The introduction of Continuously Variable Valve Timing, (CVVT), on 1999 Model Year AJ27 (normally aspirated) engines has required a change of timing unit from the one used on AJ26 engines. The CVVT unit can be identified by the helical splines, (A, Illustration 1), on the unit body.

ILLUSTRATION 1

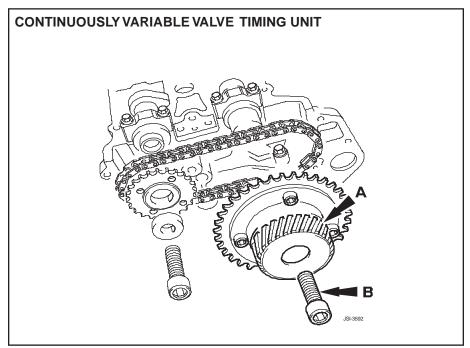
The retaining bolt for the CVVT unit, (B, Illustration 1), has an oil passage drilled through the center and requires a lower torque specification when the unit is assembled to the camshaft.

Note: The torque specification of **115 - 125 Nm specified in JTIS section 303-01**, which is applied to the VVT retaining bolt on AJ26 engines, **must not be applied** to the CVVT retaining bolt on AJ27 engines.

Note: When assembling the CVVT unit on the camshaft, the retaining bolt must be first tightened **30-40 Nm**: and then **to 85-90 Nm**.
